Ameren Illinois Company's Response to RA Study Jan 2026

Technical Questions (Mitigation Plan Inputs & Analysis)

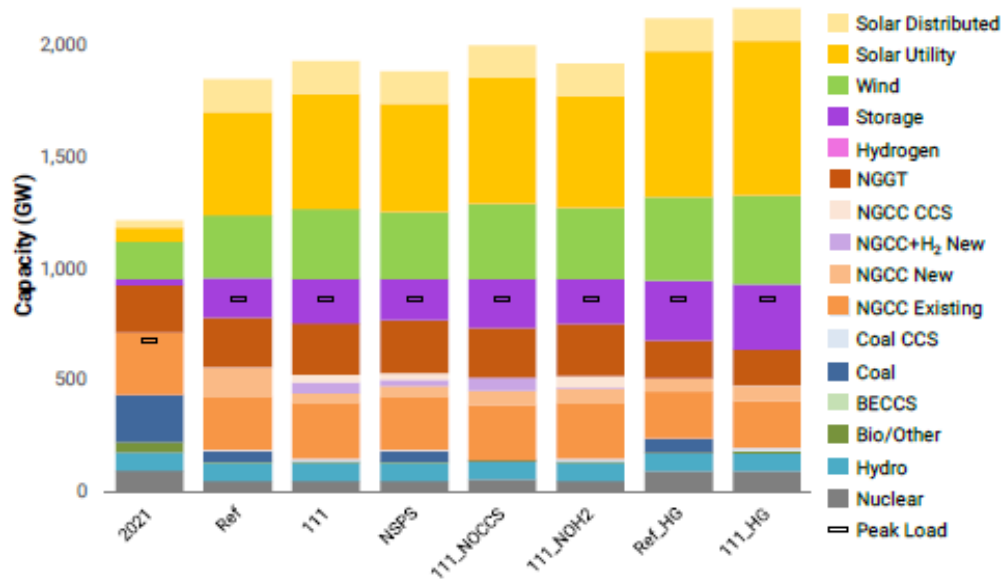
Recommend adding respective Peak Load values to stacked-bar capacity charts (Installed Capacity and Accredited Capacity) on Slides 38-41 of the Resource Adequacy Study Workshop deck dated 1/27/26, and to similar charts going forward. The comparison is useful in illustrating the relative capacity levels of various technologies against peak load projections for a reliable portfolio.

EPRI routinely includes Peak Load in their Capacity-by-technology charts of reliable portfolio alternatives. The example below is from EPRI's Analysis of EPA's Proposed New and Existing Source Standards for Power Plants, dated January 26, 2024, Product ID [3002028858](#). Multiple EPRI studies and documents have similar Peak Load vs Generation Capacity charts, including the Zero CO2 Electric Sector Policy & System Reliability report (3002026594, March 2024), the 2022 REGEN Scenarios Analysis (3002024235, December 2022), and the LCRI Net-Zero 2050: U.S. Economy-Wide Deep Decarbonization Scenario Analysis (December 2022).
